# Cascadia Chassis Side Fairing Lower Air Deflector Retention

31-32

**Freightliner  
Service Bulletin**

**Description of Revisions:** *This bulletin replaces the version dated May 2013. The procedure has been revised to use production retaining clips.*

**Fig. 1, The older C-clip and more recent high clamping force clip.**

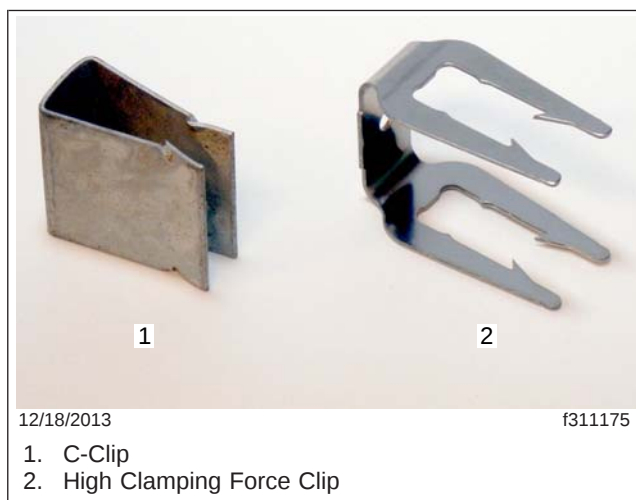
Cascadia vehicles with aerodynamic side fairings built before August 19th, 2013 have chassis side fairing lower air deflectors attached with C-clips that could become loose if dislodged or disturbed. In certain circumstances, a deflector may separate from the vehicle. To improve the retention of air deflectors, these C-clips can be replaced with current production clips that have more clamping force.

**IMPORTANT:** Vehicles built on and after August 19th, 2013 already have the newer retaining clips with higher clamping force installed. See [Fig. 1](#) for the difference between the older C-clips and the newer clips.

Use the same location and spacing as the existing clips. If clips are missing, the clip spacing for particular fairing configurations are shown in the installation drawing D22-69272-000 via EZWiring™ in PartsPro®. See [Table 1](#) for high clamping force clip part information.
